# UNITED STATES PATENT AND TRADEMARK OFFICE

APPLICATION NO.	FILING DATE	FIRST NAMED INVENTOR	ATTORNEY DOCKET NO.	CONFIRMATION NO.
10/585,919	08/06/2008	Tatsuhiko Nagata	1958.1004	1652
21171	7590	05/12/2010		
STAAS & HALSEY LLP SUITE 700 1201 NEW YORK AVENUE, N.W. WASHINGTON, DC 20005			EXAMINER SANEI, MONA M	
			ART UNIT 2882	PAPER NUMBER
			MAIL DATE 05/12/2010	DELIVERY MODE PAPER

<b>Office Action Summary</b>	<b>Application No.</b> 10/585,919	<b>Applicant(s)</b> NAGATA, TATSUHIKO	
	<b>Examiner</b> MONA M. SANEI	<b>Art Unit</b> 2882

## **DETAILED ACTION**

- 1<sup>st</sup> modified fig. 4 -

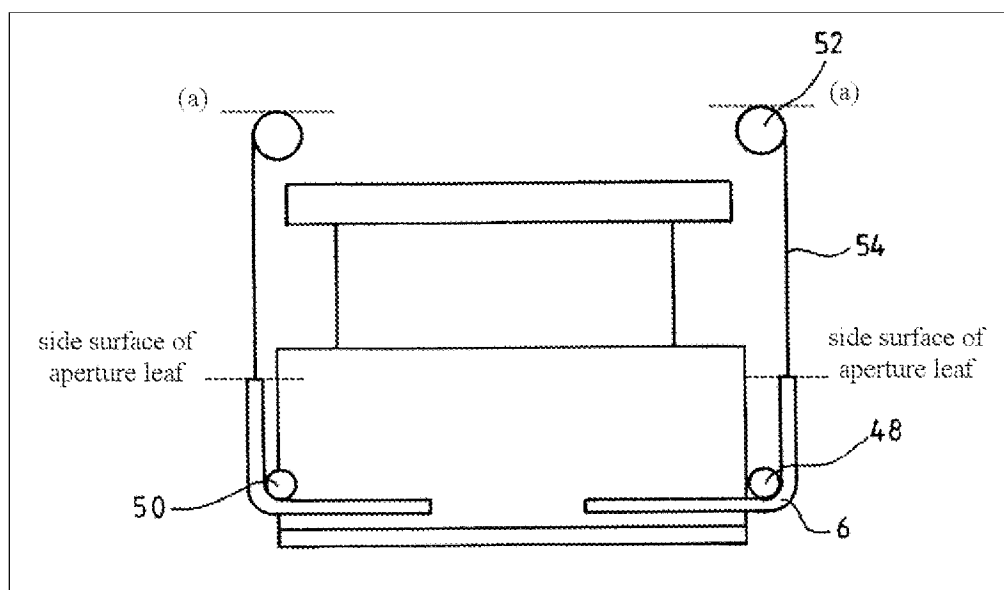
- Regarding claim 1, Saladin et al. teaches an irradiation field limiting device which shields radiation from a radiation source (38) by driving a plurality of aperture leaves (4, 6, 8, 10), arranged in a thickness direction (see figs. 2 and 4), a specific amount to limit an irradiation field to a desired range (para 0013), the irradiation field limiting device comprising:

a flexible linear member (54) secured to a thick portion of the aperture leaf (fig. 4; para 0019, lines 16-17) and provided such that the linear member can be bent along a side surface of the aperture leaf (as the linear member 54 is wound onto the drum 52, examiner takes the position that at least at point (a), shown in 1<sup>st</sup> modified fig. 4 the linear member is being bent *along* the side surface of the aperture leaf) on a side of the radiation source (see figs. 2 and 4); and

- Regarding claim 8, Saladin et al. teaches that the aperture leaf is rectangular (see figs. 1 and 4; para 0020, first sentence).
- Regarding claim 12, Saladin et al. teaches that the aperture leaves are arranged in a thickness direction (see figs. 2 and 4) so that the aperture leaves can freely move through rolling elements (48, 50), and wherein the side surface of the aperture leaf protrudes in the thickness direction to form a holding portion which holds the rolling element (see 1<sup>st</sup> modified fig. 4 above).

- 2<sup>nd</sup> modified fig. 4 -

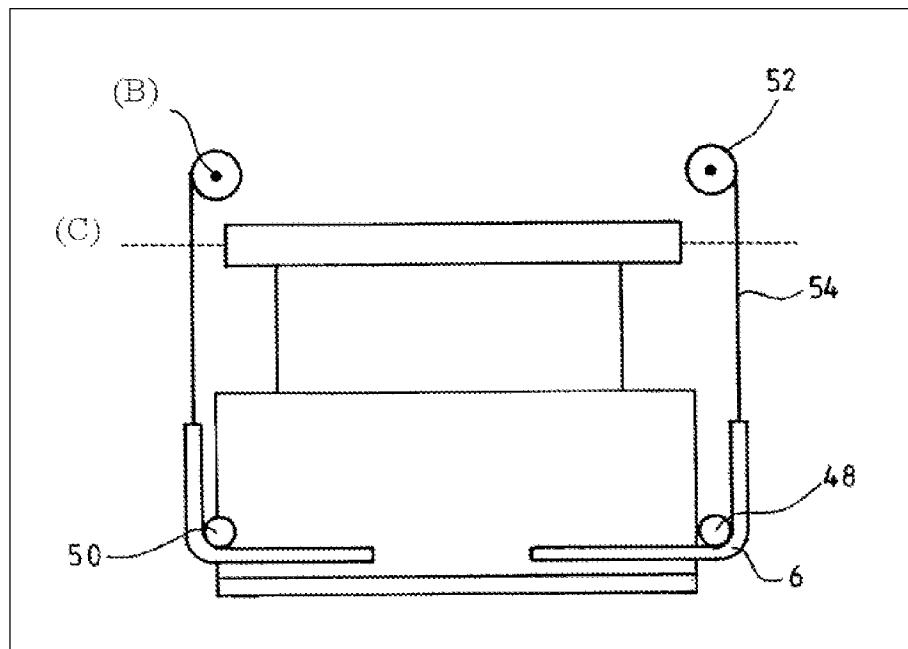
- Regarding claim 18, Saladin et al. teaches that the linear members respectively secured to the aperture leaves adjacent in the thickness direction differ in axial direction (as shown in the 2<sup>nd</sup> modified fig. 4 below, the axial direction (B), perpendicular to the plane of the figure, of the linear members 54 of the aperture leaves 6 and 10 differ from the axial direction (C) of the linear members 54 of the aperture leaves 4 and 8. To further support this position, examiner would like to point to paragraph 0019, lines 17-18 which states, "... wires 54, which are secured to the shutters to be wound onto the drums").

- Regarding claim 19, Saladin et al. teaches that the driver section drives the aperture leaf (para 0019, last sentence; para 0014, lines 6-10) of which the axial direction of the linear member is set to be identical in units of a specific number of the linear members (as shown in the 2<sup>nd</sup> modified fig. 4 above, the axial direction of the linear member 54 of aperture leaf 6 is

- 3<sup>rd</sup> modified fig. 4 -

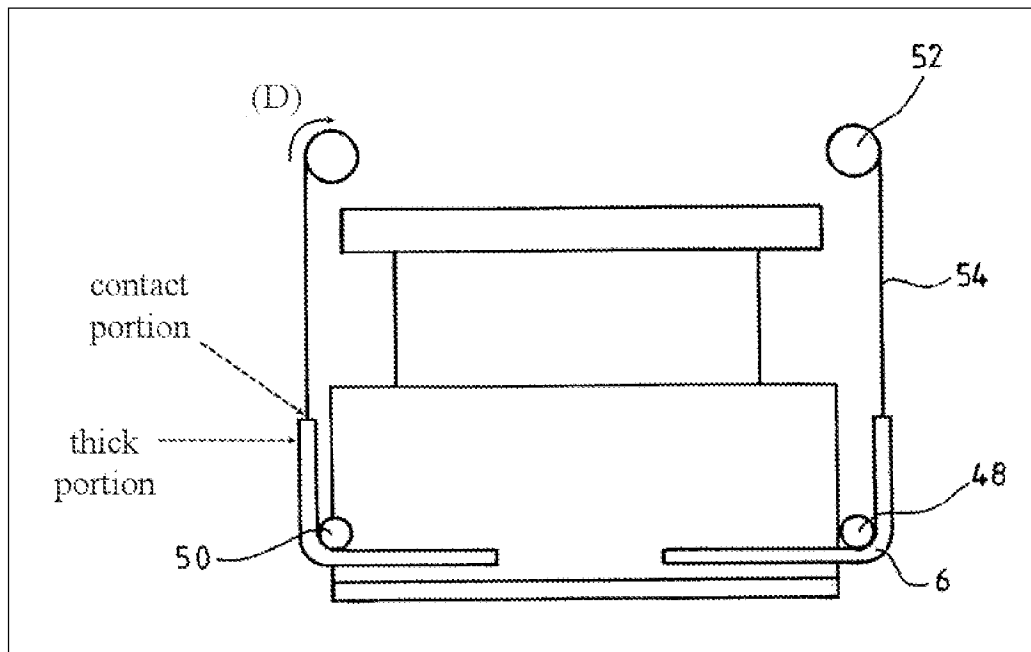
- Regarding claim 22, Saladin et al. teaches that the linear member drives the aperture leaf while contacting the thick portion (fig. 4; para 0019, lines 16-17; see 3<sup>rd</sup> modified fig. 4 below), is preliminarily bent in a direction away from a contact portion between the linear member and the thick portion (see 3<sup>rd</sup> modified fig. 4 below), and presses a portion (52) in contact with the thick portion (via the linear member 54) so that the linear member is prevented from buckling (the tension created in the linear member as a result of being wound onto the drum 52 prevents buckling of the linear member; para 0019).
